PONDEROSA AT LORSON RANCH FILING NO. 3
 A REPLAT OF TRACT "L" OF "PONDEROSA AT LORSON RANCH FILING NO. 1", BEING A PORTION
 OF THE N 1/2 SECTION 14, T15S, R65W OF THE SIXTH P.M., EL PASO COUNTY, COLORADO

FINAL PLAT
 PONDEROSA AT LORSON RANCH
 FILING NO. 3
 JOB NO. 70-083
 DATE PREPARED: 06/19/2020
 DATE REVISED: 09/03/2020

plat V_2redlines.pdf Markup Summary 10-1-2020

GENERAL PLAT NOTES: (CONT.)

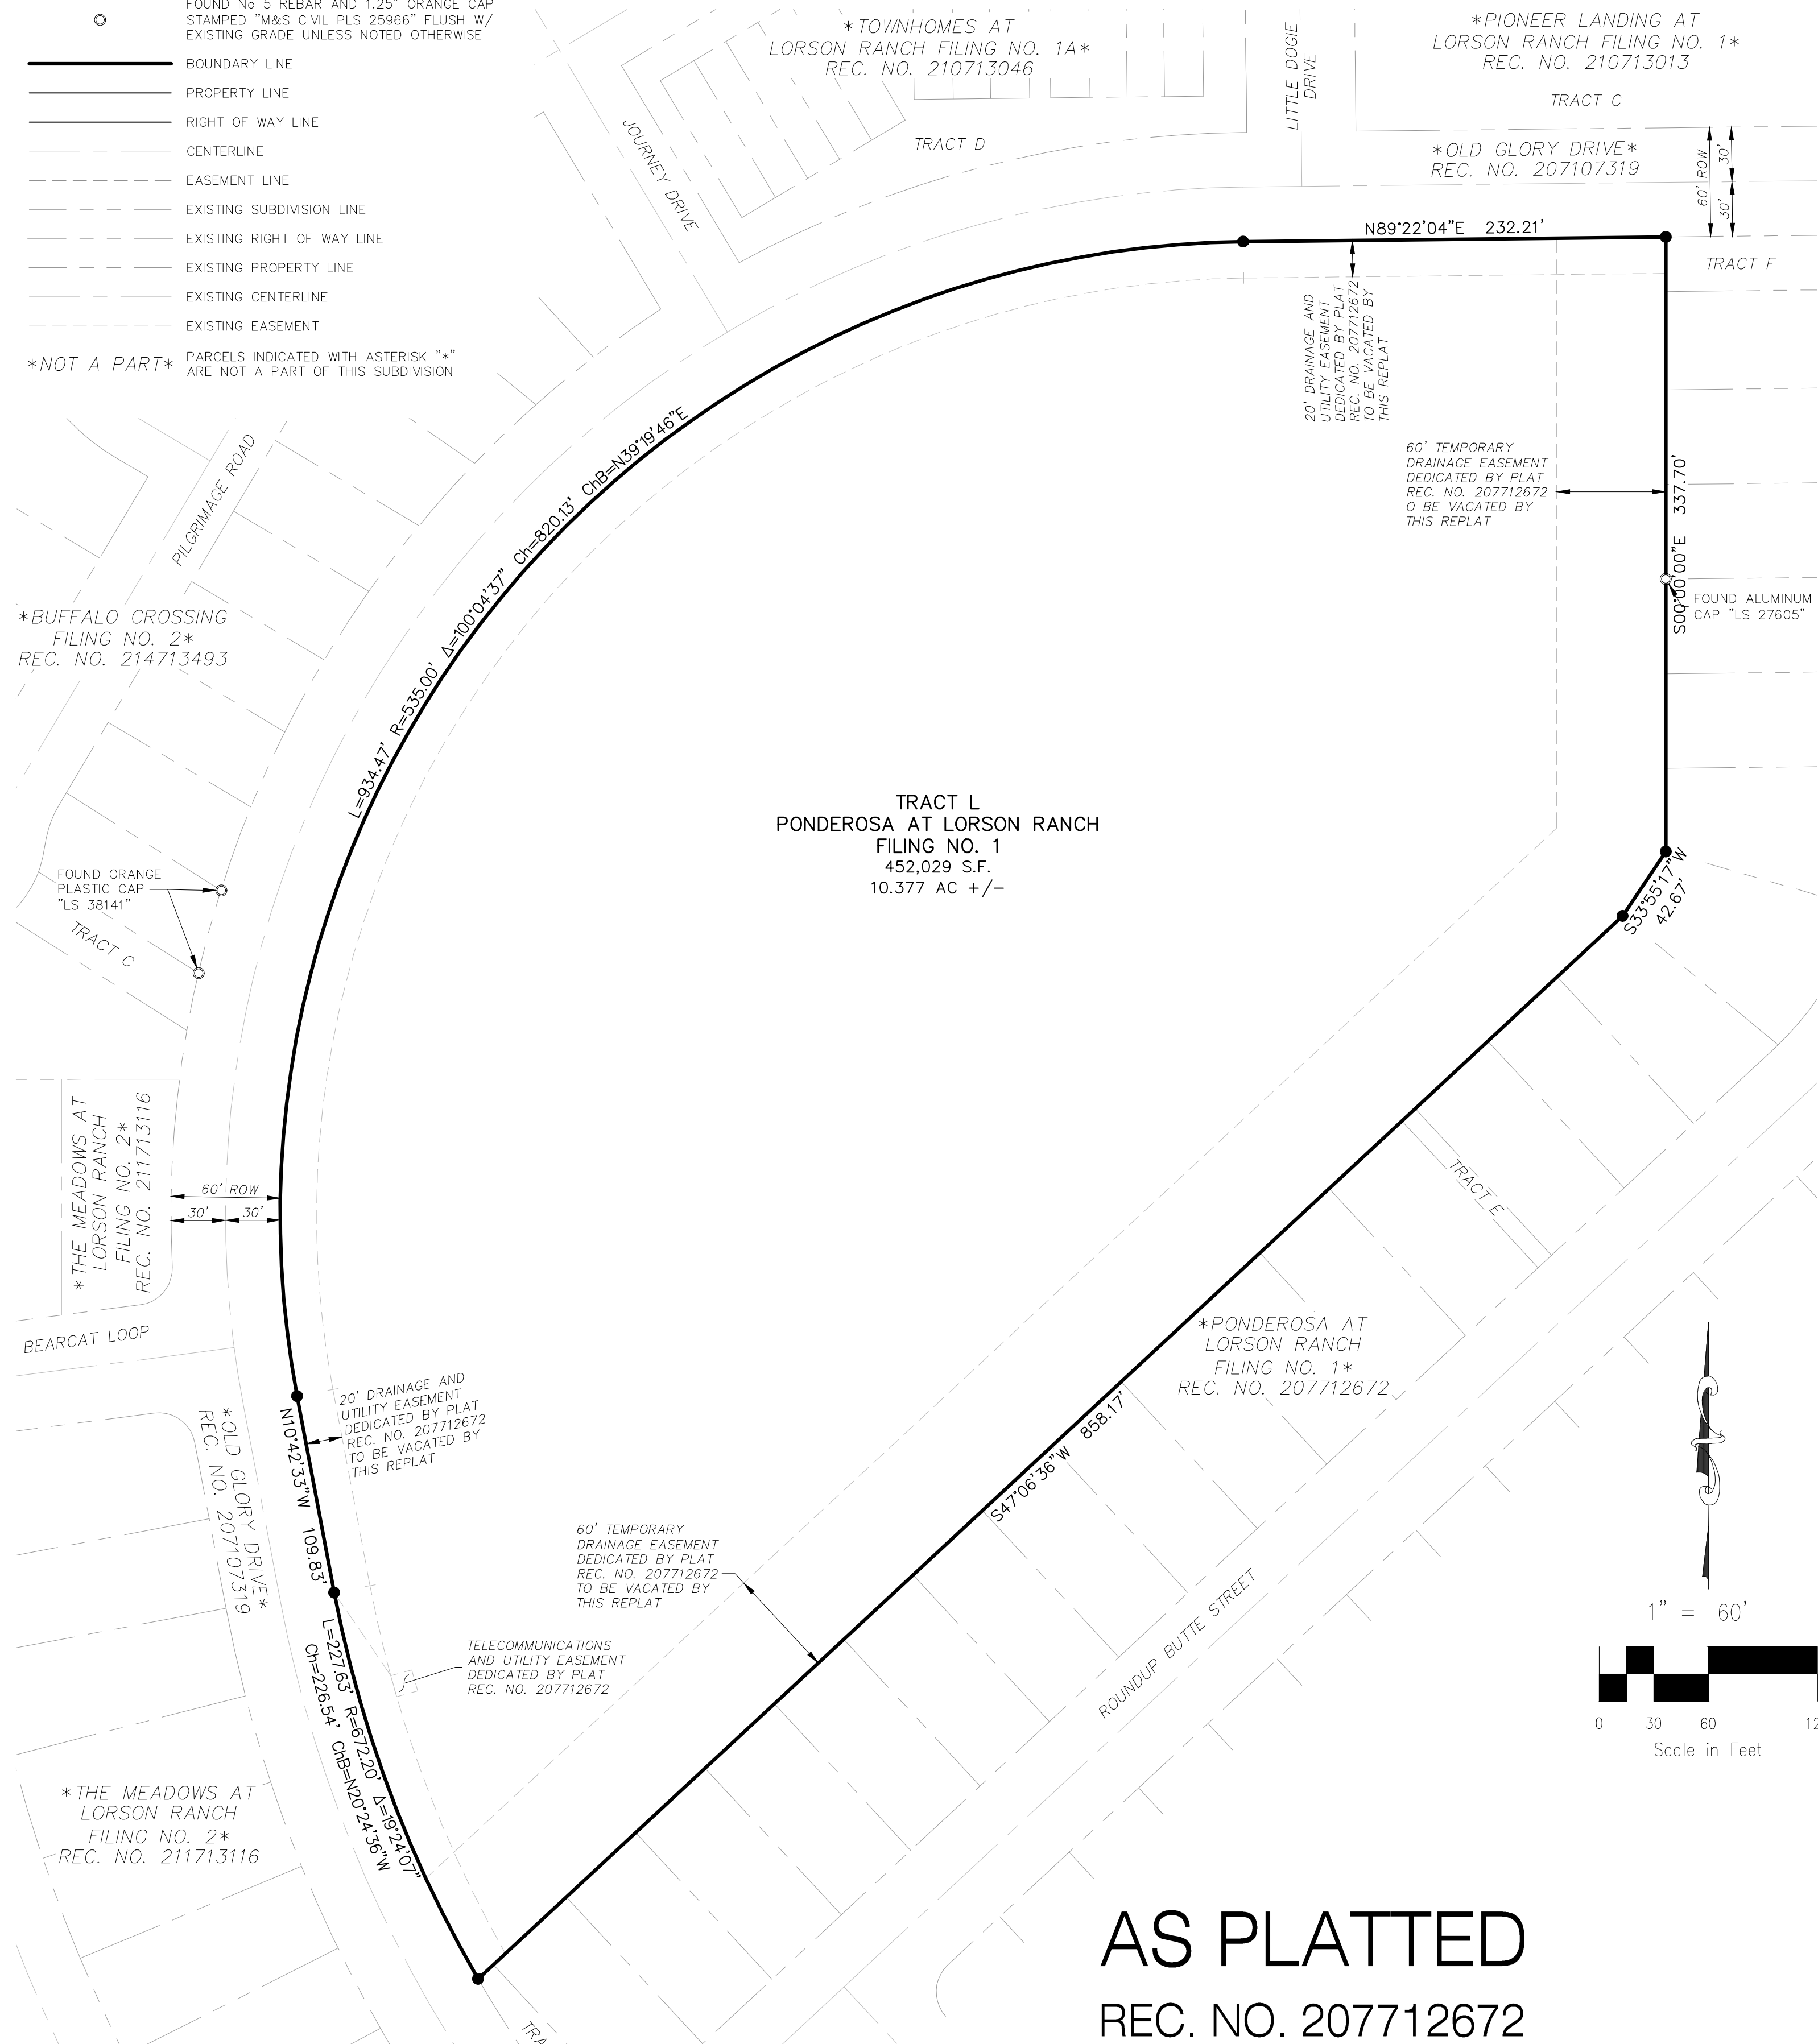
Remove. Sight distance easement is already covered with note 10.
